PRELIMINARY CITY
SOMERSET STREET
EXTENSION REDESIGN

SK-3

Title: PARKING LOT -SALVAGED GRANITE CURBING

Project: BAYSIDE BOWL

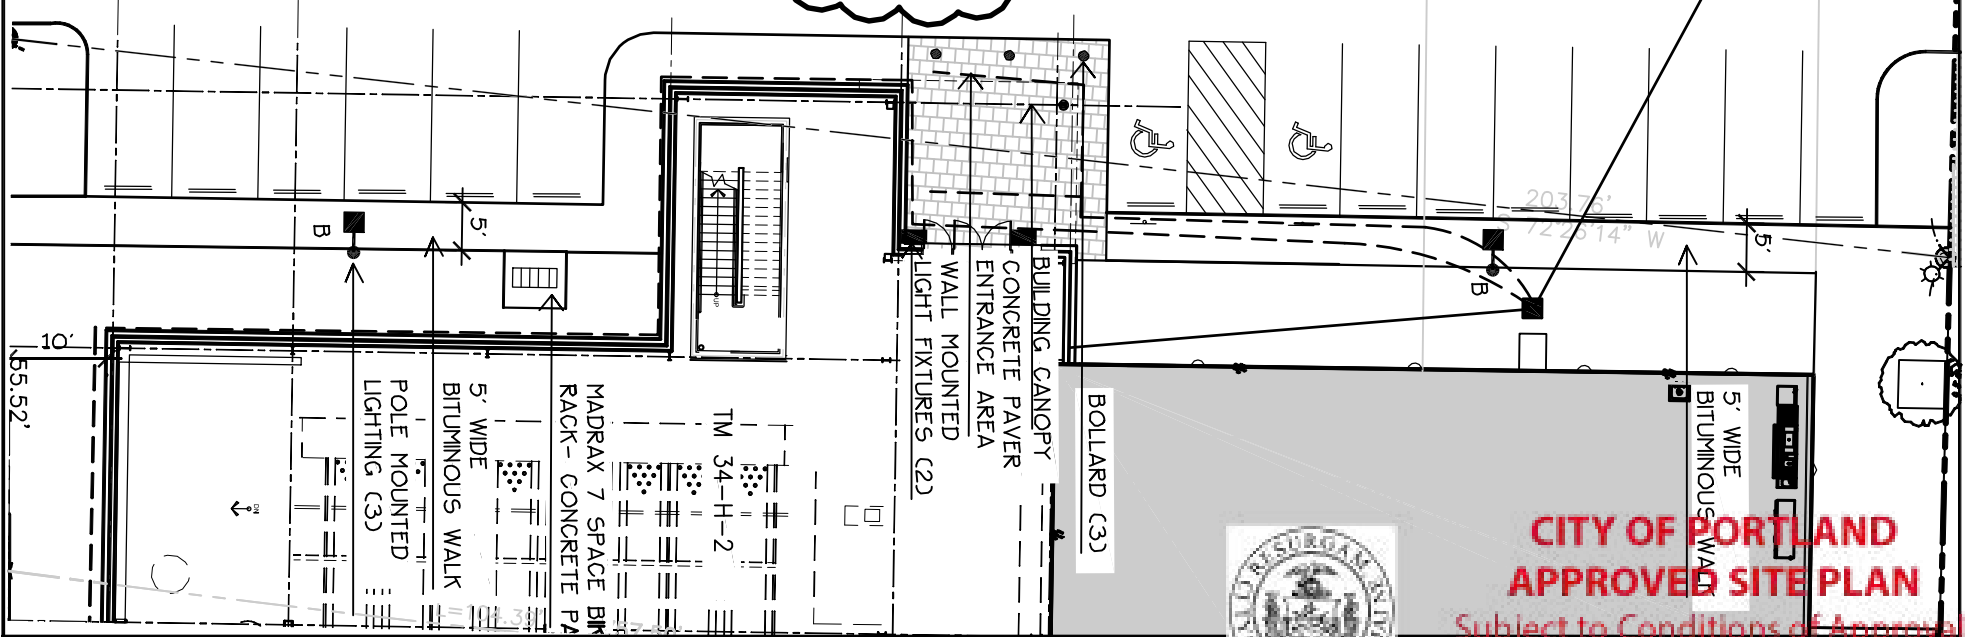
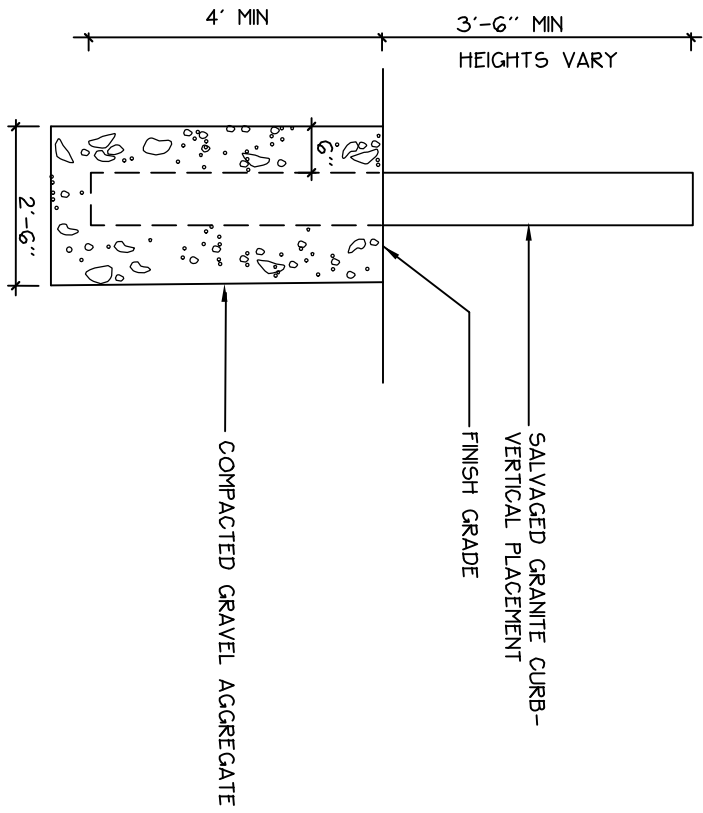
INSTALL 7-10 VERTICAL GRANITE POSTS. SPACING BETWEEN POSTS SHALL NOT EXCEED 6 FEET (EXCEPT ADJACENT TO LIGHT POLE). POSTS SHALL BE SET TO DETER DRIVING INTO PLANTING BED-TYP.

REMAINING SHORTER GRANITE SECTIONS SHALL BE FIELD LOCATED

BOULDERS SHOWN ON PREVIOUS PLAN ELIMINATED

INSTALL 3-4 SALVAGED GRANITE POSTS ORIENTATION TO BE DETERMINED IN THE FIELD
